Subject: VIRGIL C. SUMMER NUCLEAR STATION  
DOCKET NO. 50/395  
OPERATING LICENSE NO. NPF-12  
RESPONSE TO INITIAL QUESTIONS DATED  
OCTOBER 23, 2000  
MSP 00-0244

## Responses to NRC Questions on

### A loop hot leg crack

Dated 10/23/2000

FIGURE 2  
VC SUMMER NUCLEAR STATION  
"A" LOOP HOT LEG NOZZLE  
EXISTING WELD DESIGN

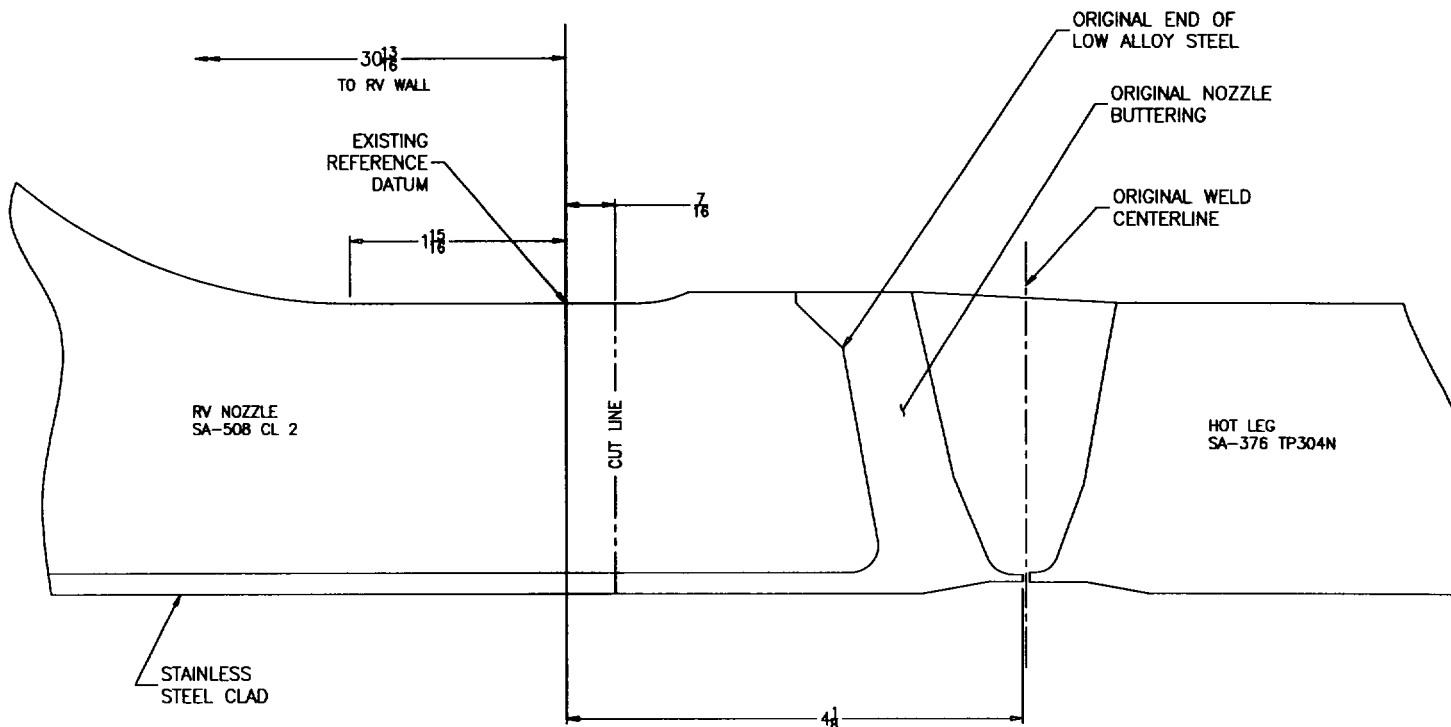
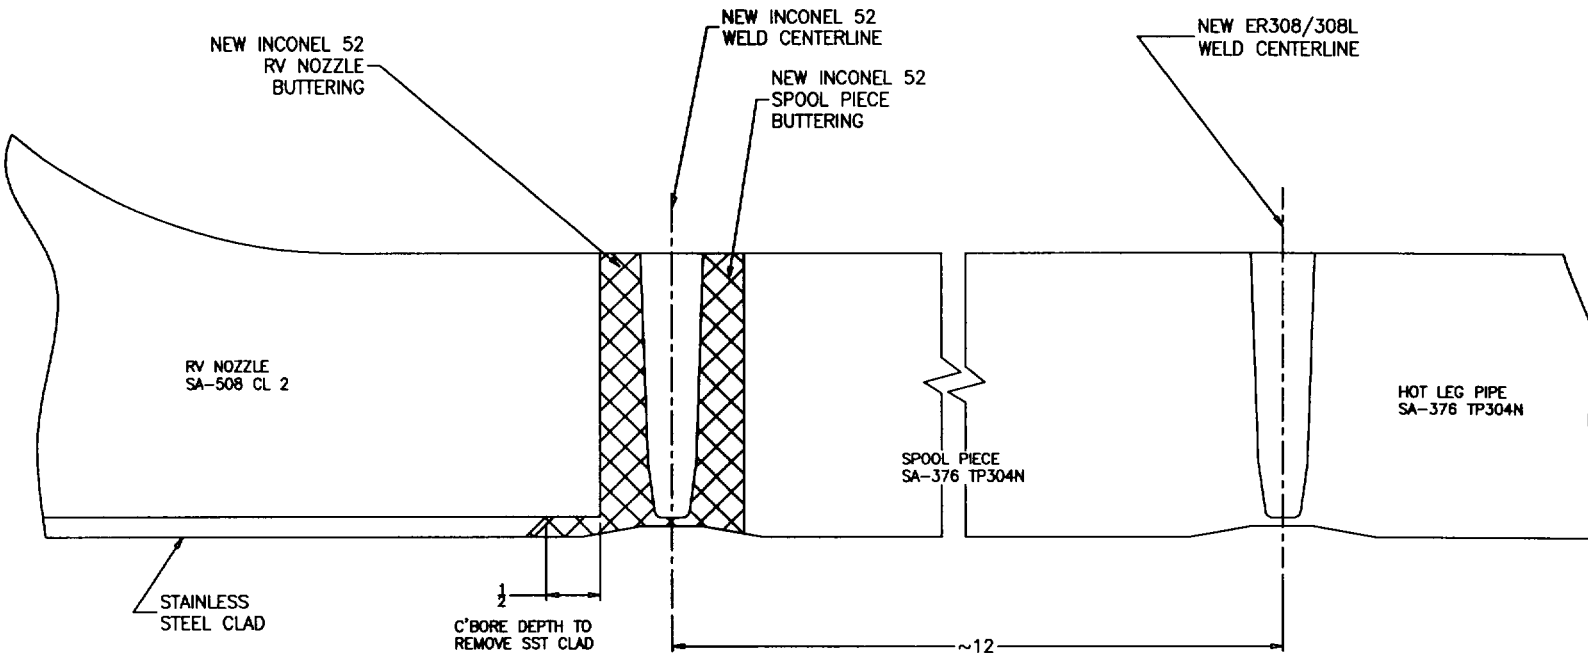
9. Describe in detail the schedule and scope for performing repairs for the subject weld.

The pre-existing field configuration is illustrated in Figure 2. The repair plan included the removal of the defective weld along with all of the nozzle butter and approximately 8 inches of the pipe. A stainless steel pipe spool piece was welded back in to restore the integrity of the RCS (Figure 3).

The entire weld was removed and made available for failure analysis to support the root-cause evaluation. Ultrasonic examination was performed to determine the cut line on the reactor vessel side of the weld and assure complete flaw removal. Approximately 12 inches from this cut line (away from the vessel) a second cut was made to allow access to the nozzle. Both the A hot leg piping and the A steam generator were restrained to prevent any undesired movement.

The nozzle was built up with Alloy 52 to prepare for the nozzle-to-spool weld. The stainless steel cladding on the inside of the nozzle was removed for a distance of 1/2 inch from the nozzle end. The cladding was replaced with Alloy 52. Both activities were completed using machine gas tungsten arc welding (GTAW) and using the temper bead process.
